Hallsville School District

All Purpose Field & Parking Lot Primary School Classroom Addition Secure Entry Doors

Progress Report #5

CHANGE ORDER REQUEST No. 14

OVERALL SITE
UTILITY PLAN

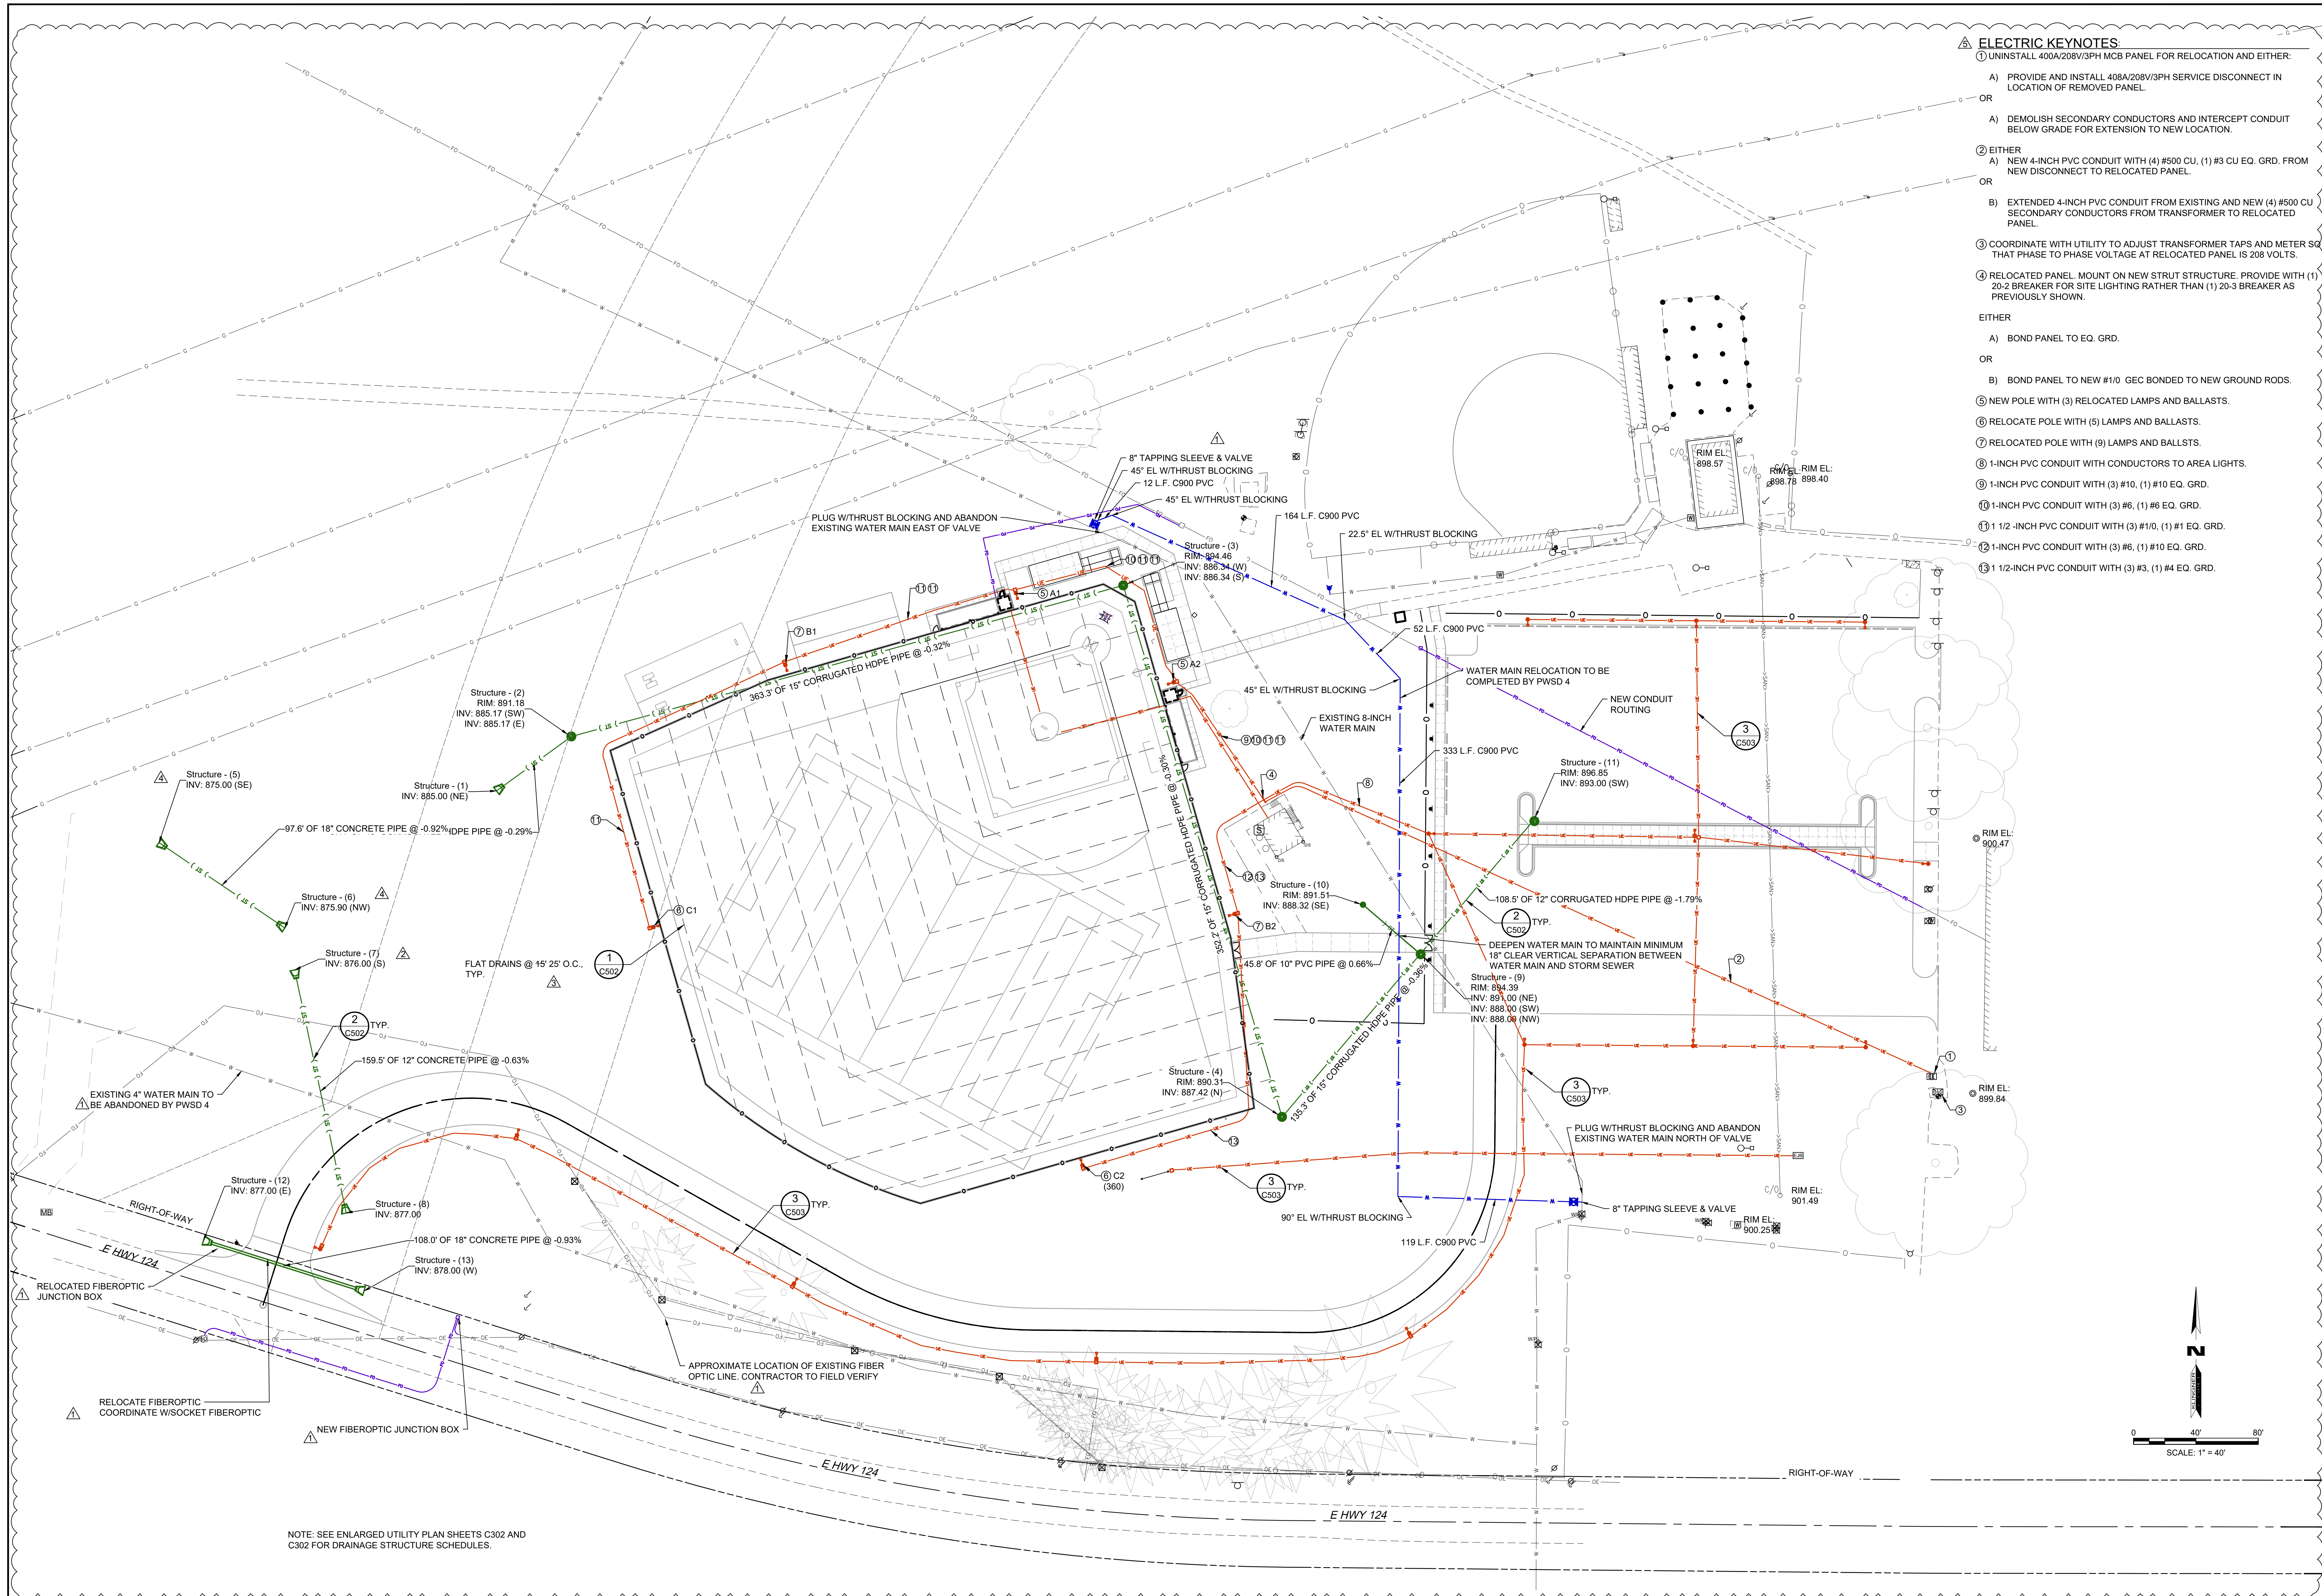
1	Sheet C301	REVISE Site Utility Plan to show new field lighting layout, relocation of electrical panel PRL1, and adjust locations of access road lighting.

- ELECTRIC KEYNOTES:**
- ① UNINSTALL 400A/208V/3PH MCB PANEL FOR RELOCATION AND EITHER:
- A) PROVIDE AND INSTALL 408A/208V/3PH SERVICE DISCONNECT IN LOCATION OF REMOVED PANEL.

- OR
 - A) DEMOLISH SECONDARY CONDUCTORS AND INTERCEPT CONDUIT BELOW GRADE FOR EXTENSION TO NEW LOCATION.
- ② EITHER
- A) NEW 4-INCH PVC CONDUIT WITH (4) #500 CU, (1) #3 CU EQ. GRD. FROM NEW DISCONNECT TO RELOCATED PANEL.

- OR
 - B) EXTENDED 4-INCH PVC CONDUIT FROM EXISTING AND NEW (4) #500 CU SECONDARY CONDUCTORS FROM TRANSFORMER TO RELOCATED PANEL.
- ③ COORDINATE WITH UTILITY TO ADJUST TRANSFORMER TAPS AND METER SQ THAT PHASE TO PHASE VOLTAGE AT RELOCATED PANEL IS 208 VOLTS.

- ④ RELOCATED PANEL. MOUNT ON NEW STRUT STRUCTURE. PROVIDE WITH (1) 20-2 BREAKER FOR SITE LIGHTING RATHER THAN (1) 20-3 BREAKER AS PREVIOUSLY SHOWN.
- EITHER

- A) BOND PANEL TO EQ. GRD.
 - OR
 - B) BOND PANEL TO NEW #1/0 GEC BONDED TO NEW GROUND RODS.
- ⑤ NEW POLE WITH (3) RELOCATED LAMPS AND BALLASTS.
- ⑥ RELOCATE POLE WITH (5) LAMPS AND BALLASTS.

- ⑦ RELOCATED POLE WITH (9) LAMPS AND BALLASTS.
- ⑧ 1-INCH PVC CONDUIT WITH CONDUCTORS TO AREA LIGHTS.
- ⑨ 1-INCH PVC CONDUIT WITH (3) #10, (1) #10 EQ. GRD.

- ⑩ 1-INCH PVC CONDUIT WITH (3) #6, (1) #6 EQ. GRD.
- ⑪ 1 1/2 -INCH PVC CONDUIT WITH (3) #1/0, (1) #1 EQ. GRD.
- ⑫ 1-INCH PVC CONDUIT WITH (3) #6, (1) #10 EQ. GRD.

- ⑬ 1 1/2-INCH PVC CONDUIT WITH (3) #3, (1) #4 EQ. GRD.
